Title of Change:	NTMFSS0D9N03P8 Pin Definition and Marking Change.
Effective date:	23 Aug 2023
Contact information:	Contact your local onsemi Sales Office or Rodrigo.Milana.Jr@onsemi.com
Type of notification:	This Product Bulletin is for notification purposes only. onsemi will proceed with implementation of this change upon publication of this Product Bulletin.
Change Category:	Assembly Change
Change Sub-Category(s):	Datasheet/Product Doc change

This Product Bulletin is issued to inform all impacted customers of the below affected PQFN 5x6 Source Down parts on the changes in their pin definition and marking (Pin 1 location) to standardize the Source Down package pin definition.

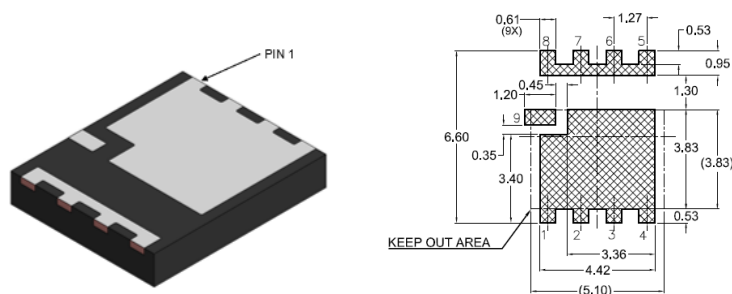
Before:

After:

No changes on the electrical performance of the affected parts are expected on above changes.
